Addendum No. 4

November 30, 2018

**R. M. T. Johnson Elementary School
Renovations & Additions
500 Whittlesey Drive
Bethel, CT 06801
State Project No. 009-0059 RNV
Phase 1 of 2**

SKS-2

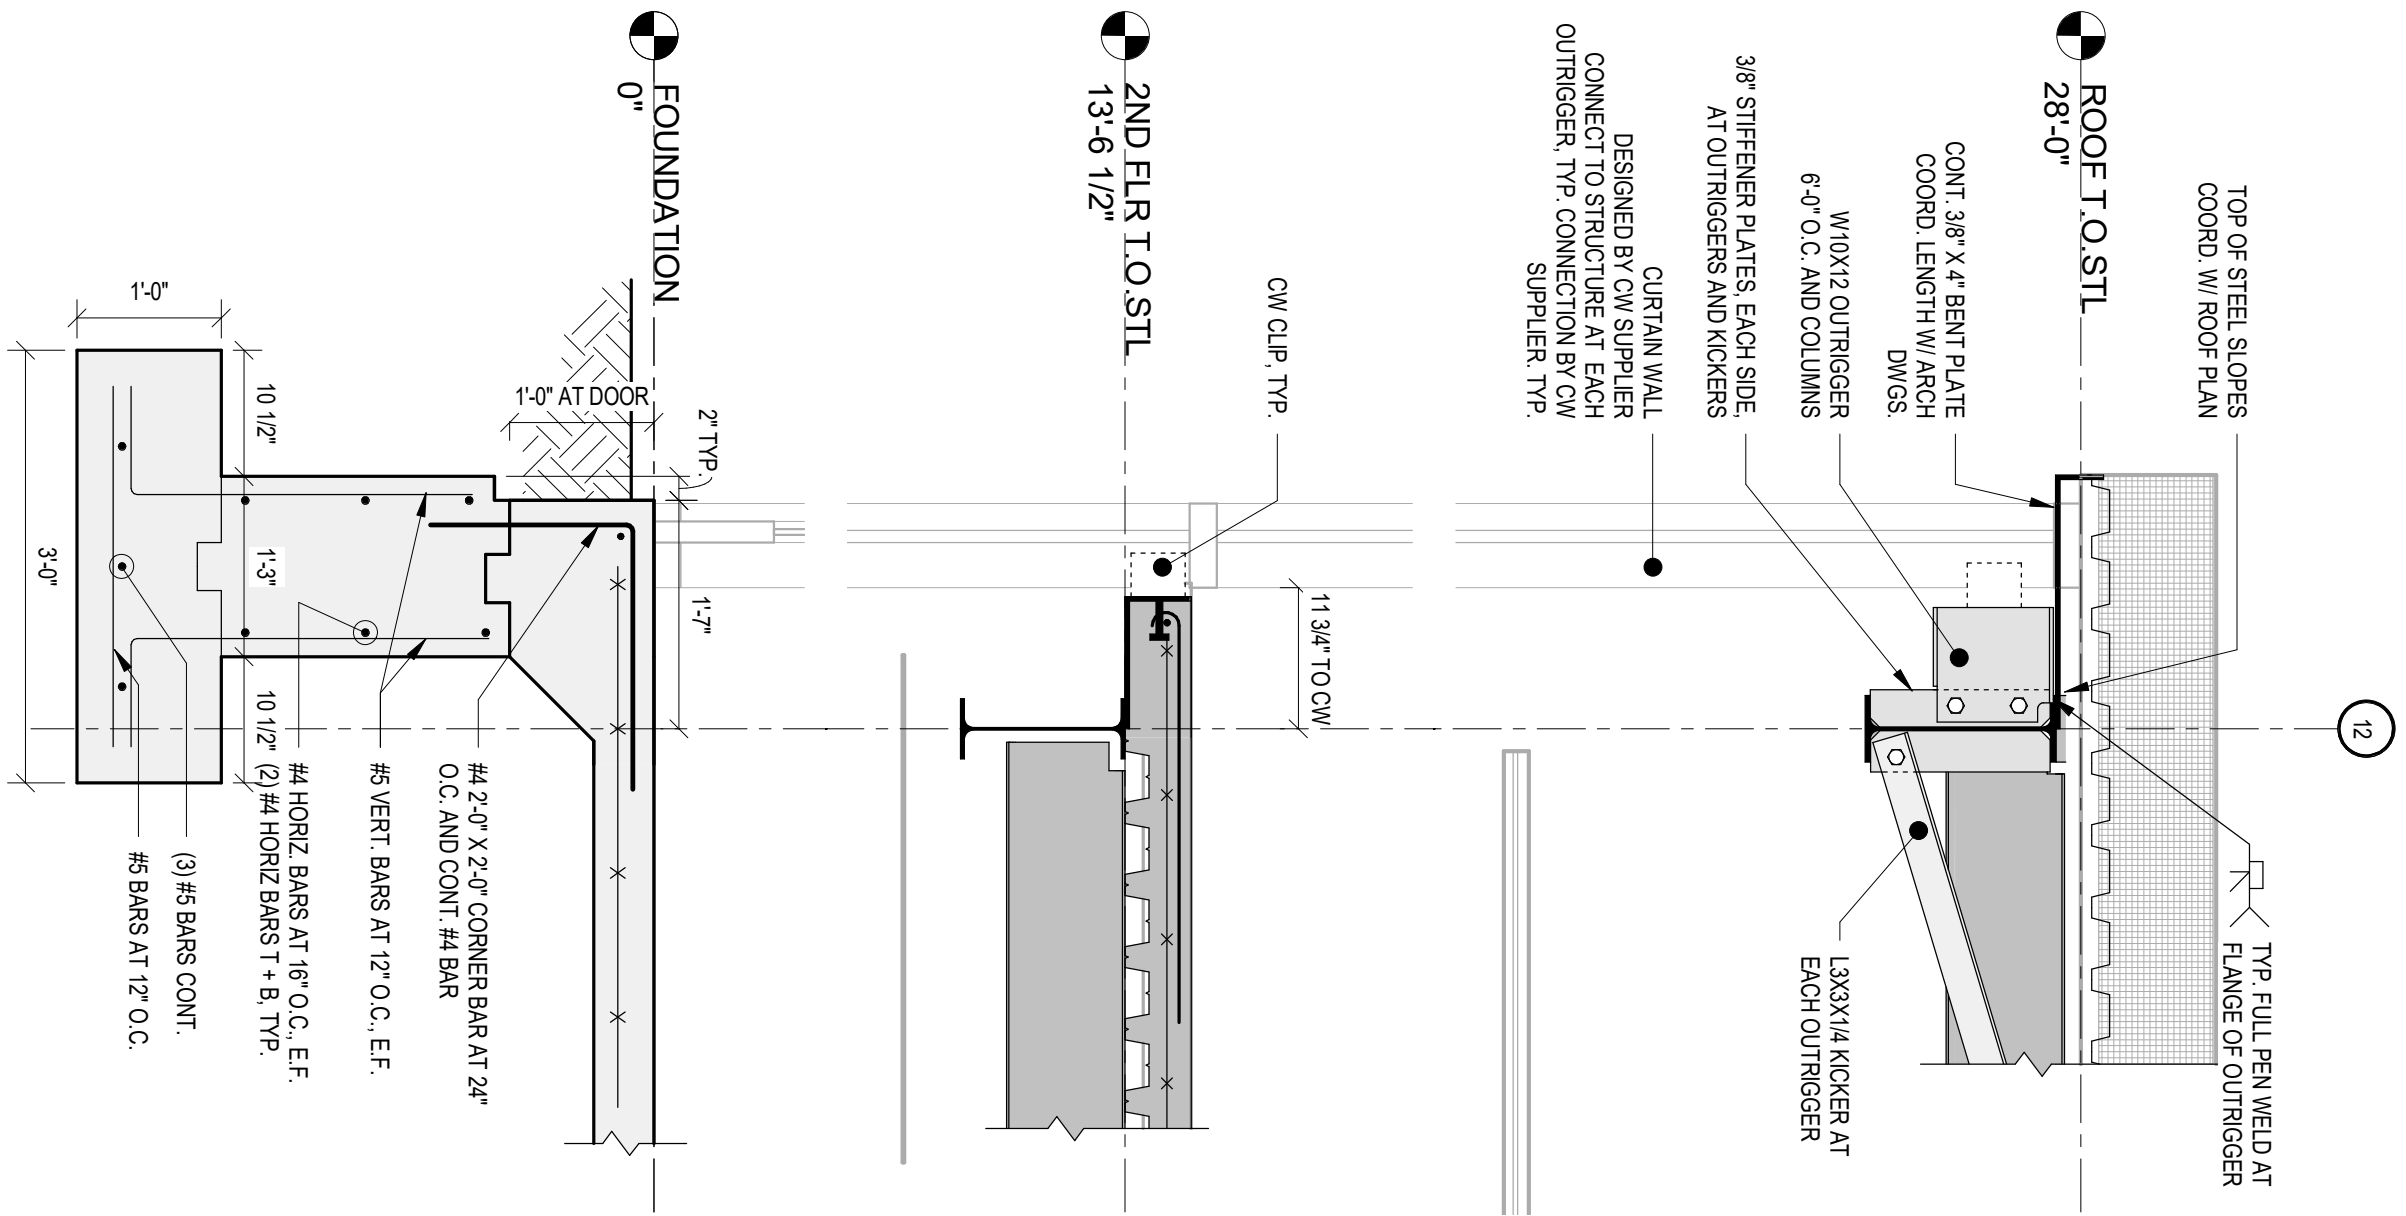
At the lobby C101 near grid X6 where existing wall is being demolished and curtainwall CW14 is being installed provide reference to typical detail, Typ. Connection From New Curtainwall to Existing Structural Member . See sketch SKS-2 for typical detail.

At the cafeteria along grid 9 where existing wall is being demolished and curtainwall CW2a is being installed provide reference to typical detail, Typ. Connection From New Curtainwall to Existing Structural Member . See sketch SKS-2 for typical detail.
